# *Florence County Government*

### **ADDENDUM NO. 2 - FRIENDFIELD FIRE STATION (BID NO. 2-16/17)**

CONSTRUCTION PLANS  
FOR:  
**HANNAH-SALEM-FRIENDFIELD  
FIRE DEPARTMENT  
NEW STATION AT FRIENDFIELD**

CLIENT:	HANNAH-SALEM FRIENDFIELD FIRE DEPARTMENT	DESCRIPTION:	MECHANICAL DETAILS
PLAN SET:	NEW STATION AT FRIENDFIELD	DATE:	DESIGN JUL 21, 2016
DESC:	MECHANICAL DETAILS	PROJECT:	AE055
		SHEET:	M3.0

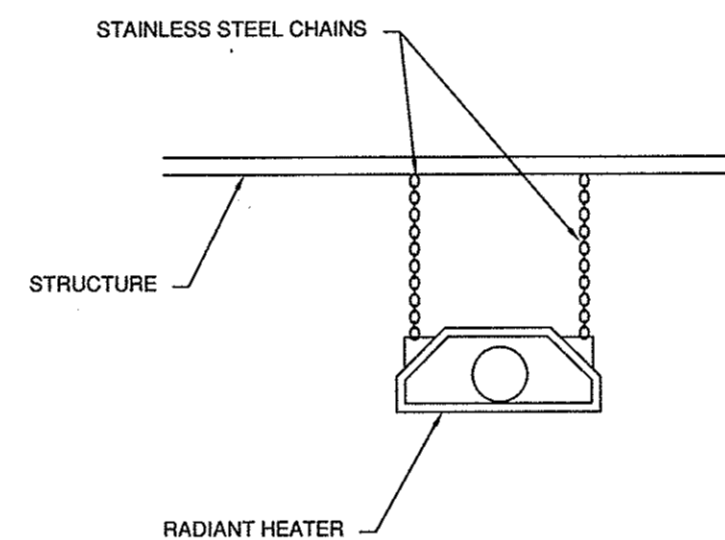
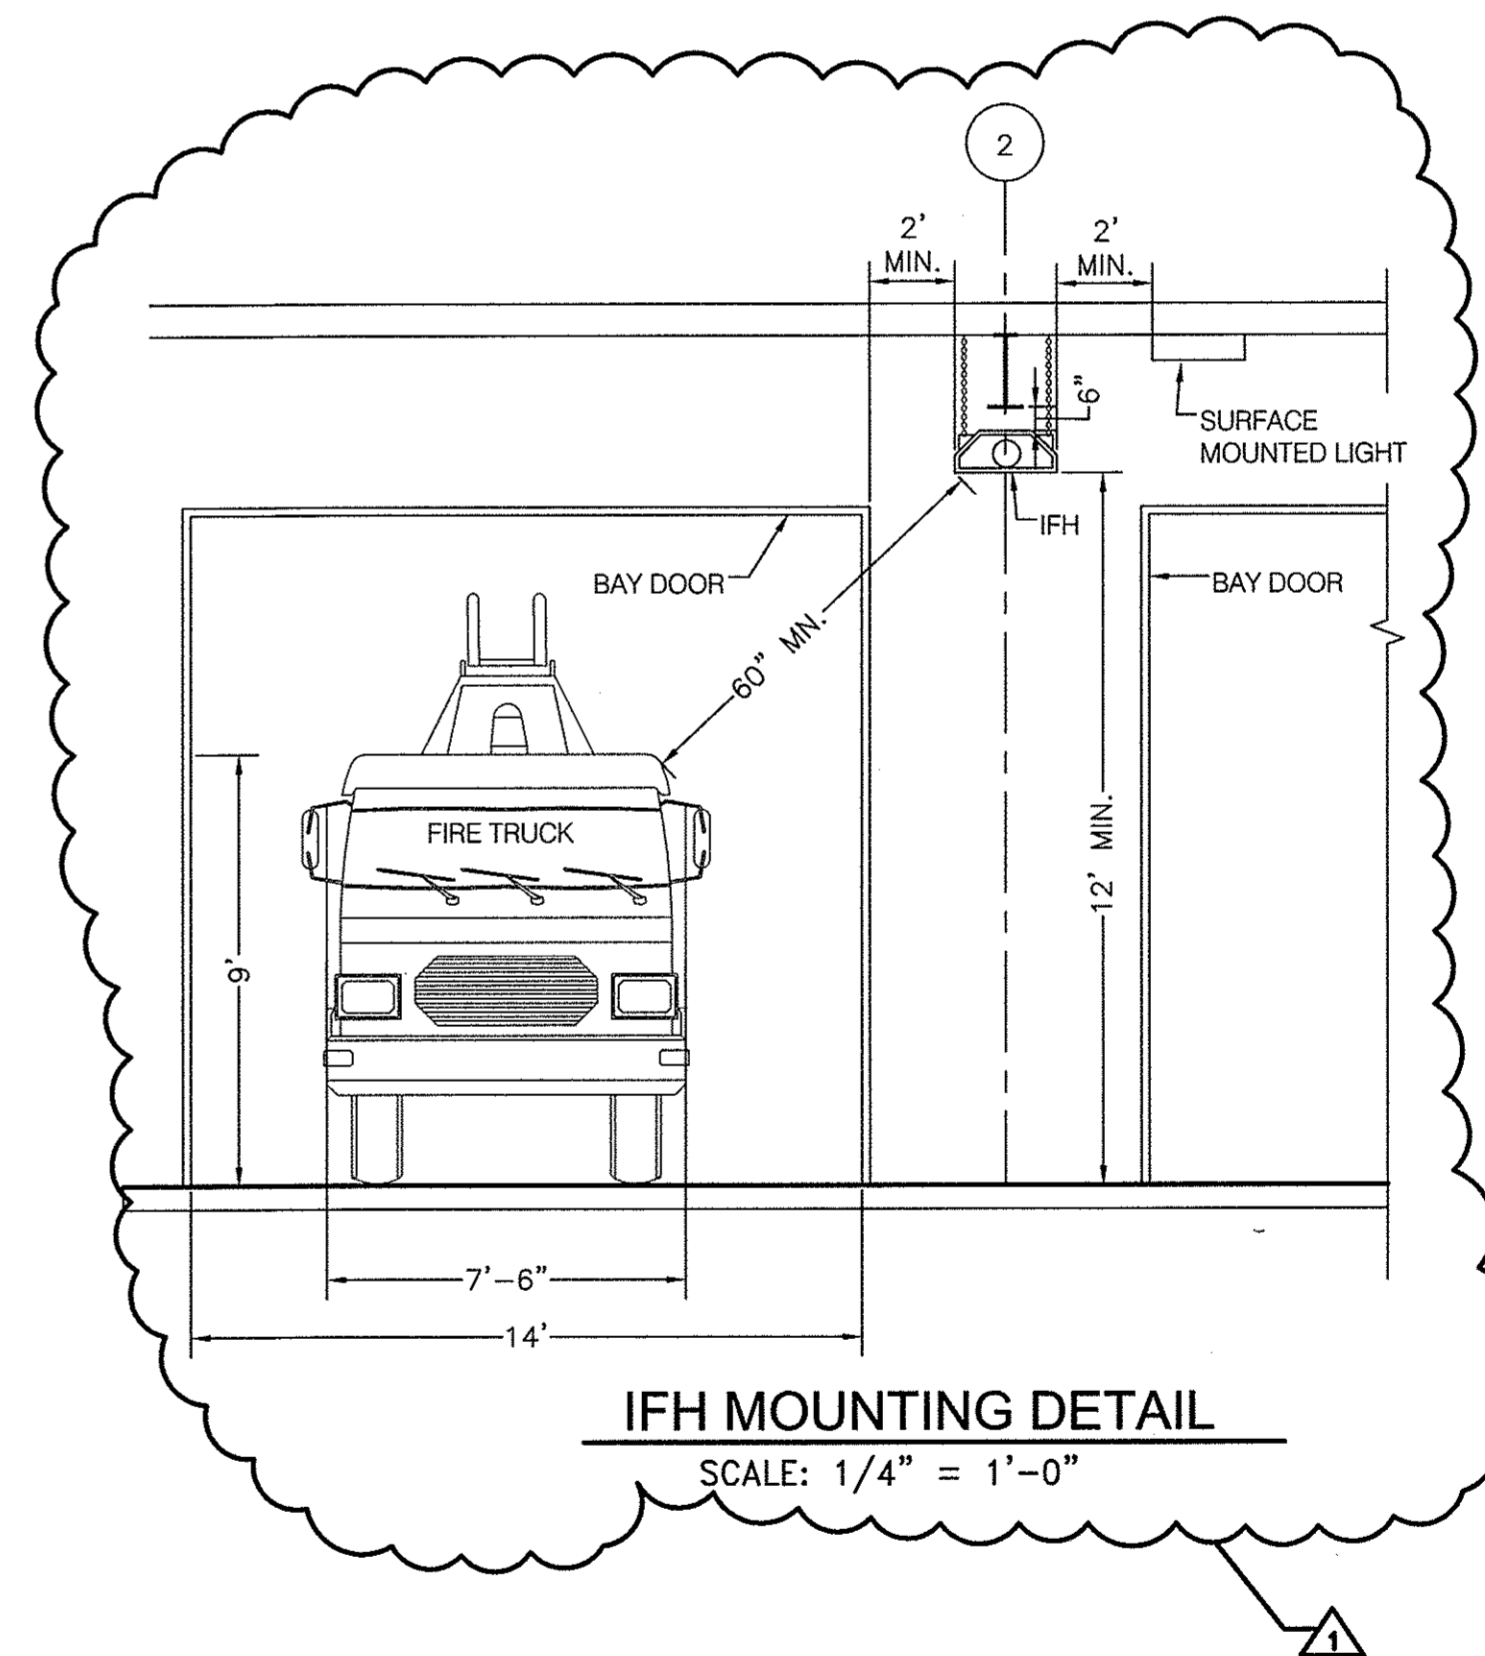
- Sheet M3.0 Added minimum clearances for the IFH-1 unit.
- Sheet E1.0 Added missing information for the wall heaters, EWH-1 and EWH-2.
- Sheet E2.0 Lights HB-1 will be surface mounted to avoid conflicts with IFH-1 and the overhead doors.  
The OB lights will have different mounts:  
The flagpole light will be ground mounted.  
The sign light will be wall mounted.  
BX Cabling is allowed as an alternate to conduit.

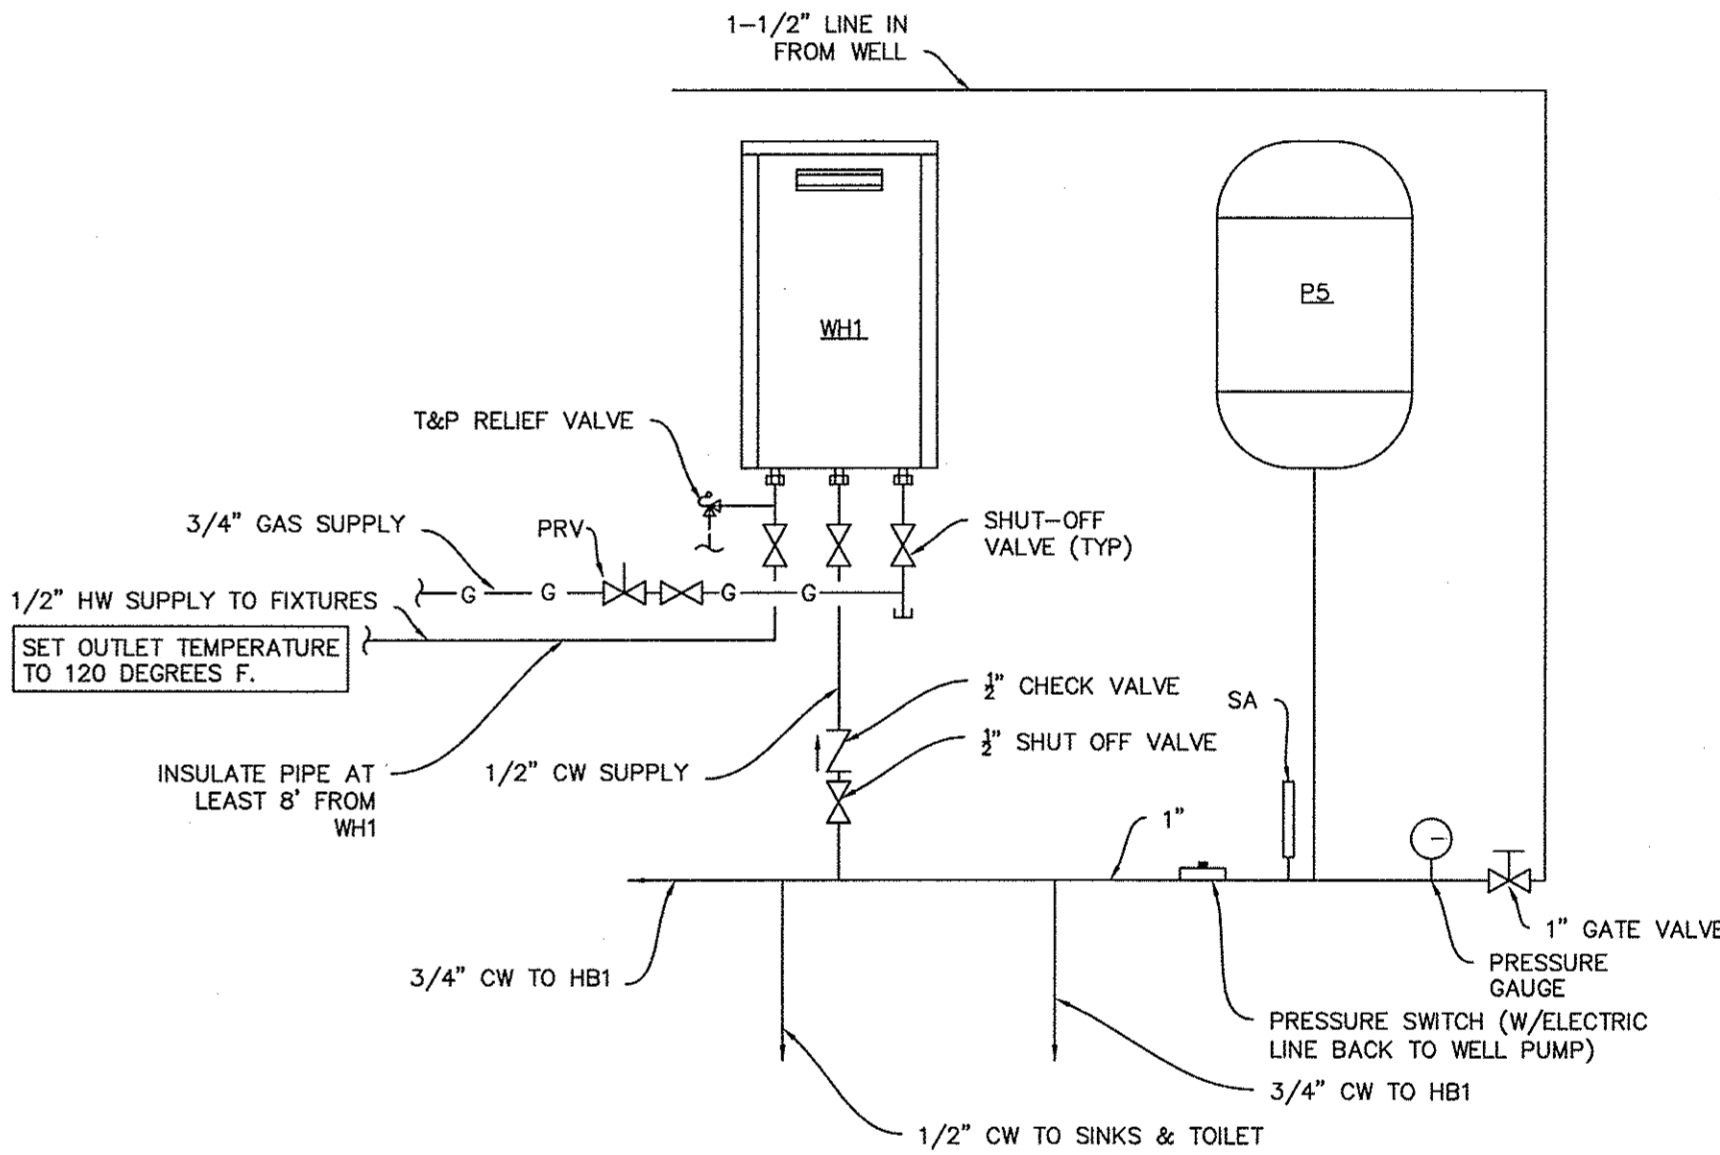
- Sheet P1.0 Exterior hose bibb HB1 shall be keyless & frostless.
- Sheet P2.0 Pex type cold water pipe is allowed below the slab.  
On hose bibs protruding from behind the metal wall liners, the shut-off valve is set above the liner for easier access.
